Access Compliance Report

Public Rights-of-Way

(Curb Ramps)

Intersection ID: 13190	Main Street: W_BLAND_ST	Cross Street: S_CHURCH_ST	Location: E
ADA ID: 90C2B81E1A50	Ramp Type: PerpDiag	Initial Pass/Fail: Fail	Overall Compliance: No
Severity Score: 33.75			
Codes/Mitigation Info/Possible Solution		Field Measurements/Component Compliance

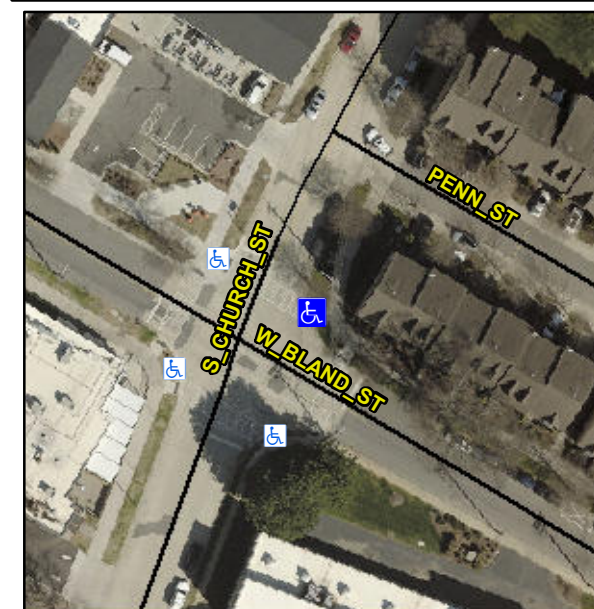
Not Found, R304.5.1, R304.5.3

Compliance	Description	Data	Compliance	Description	Data
N/A	Ramp Length (in)	112.0	Yes	Ramp Slope (%)	6.7
No	Ramp Width (in)	40.0	No	Ramp XSlope (%)	7.2
N/A	Flare Type LT	N/A	N/A	Flare Type RT	N/A
N/A	Flare Slope LT (%)	N/A	N/A	Flare Slope RT (%)	N/A
N/A	Flare Traversable LT?	N/A	N/A	Flare Traversable RT?	N/A
N/A	Landing Length (in)	N/A	N/A	DWS Provided?	N/A
N/A	Landing Width (in)	N/A	N/A	DWS Contrast?	N/A
N/A	Landing Slope (%)	N/A	N/A	DWS Length (in)	N/A
N/A	Landing X Slope (%)	N/A	N/A	DWS Full Width?	N/A
N/A	Landing Curb? (Y/N)	N/A	N/A	DWS Offset (in)	N/A
N/A	Shared Landing?	N/A			
N/A	Gutter Ponding?	N/A	N/A	Gutter Slope (%)	N/A
N/A	Gutter Lip Ht (in)	N/A	N/A	Gutter X Slope (%)	N/A
N/A	Painted X Walk1?	No	N/A	Painted X Walk2?	No
	X Walk 1 Direction	To NW		X Walk 2 Direction	To SW
N/A	X Walk 1 Width (in)	N/A	N/A	X Walk 2 Width (in)	N/A
	X Walk 1 Slope (%)	2.7		X Walk 2 Slope (%)	4.8
	X Walk 1 X Slope (%)	4.3		X Walk 2 X Slope (%)	3.3

Remove & Replace Curb Ramp With Two New Directional Ramps or Equivalent.
